SERVICE BULLETIN

SB-AG-95

Rev A: 08/20/2026

RUDDER PEDAL INTERFERENCE CORRECTION

Figure 2

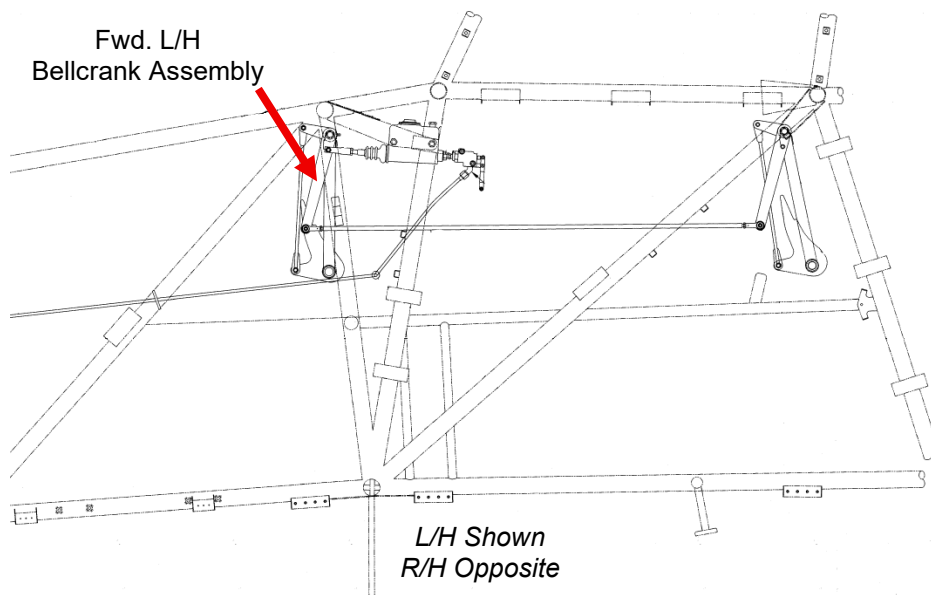
3. Remove existing L/H (forward only) and R/H forward and aft bellcrank assemblies (reference Figure 2).

Figure 3 – LH Fwd

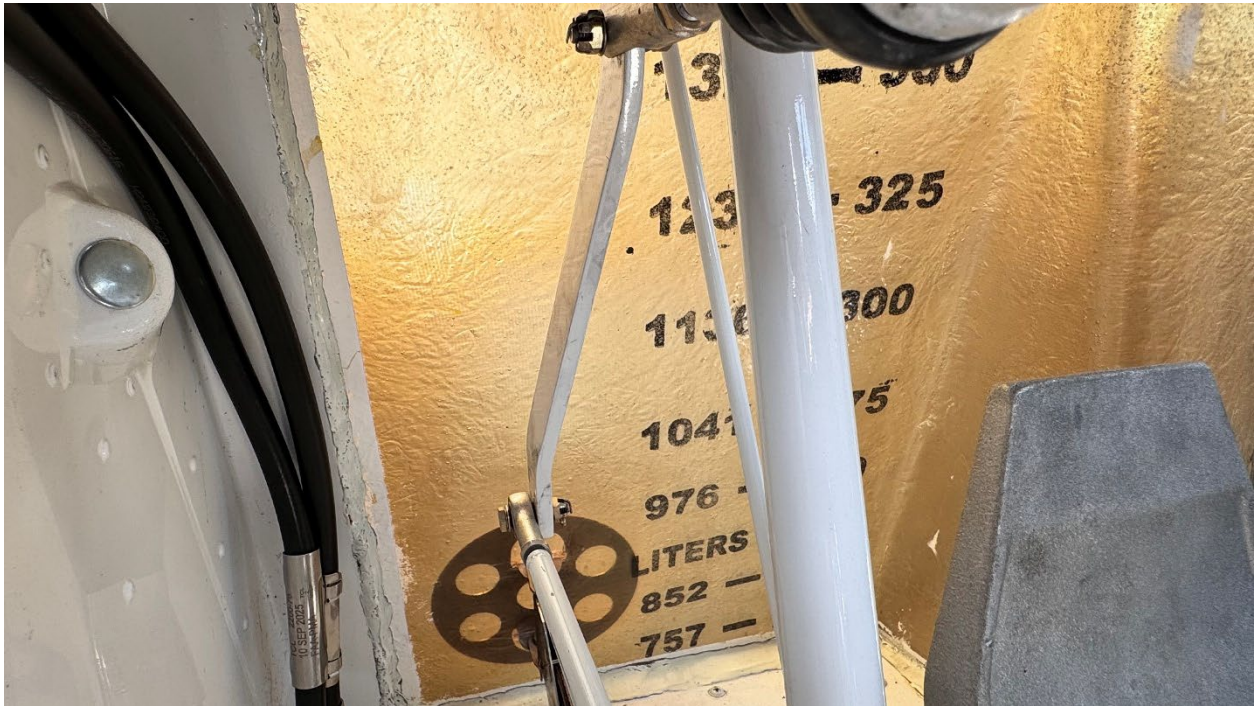
4. Install L/H (forward only) and R/H forward and aft bellcrank assemblies included in kit (reference Figures 3-5).

5. Ensure no part-to-part contact or interference present. If so, reorient hardware to allow clearance.
6. Return to service.
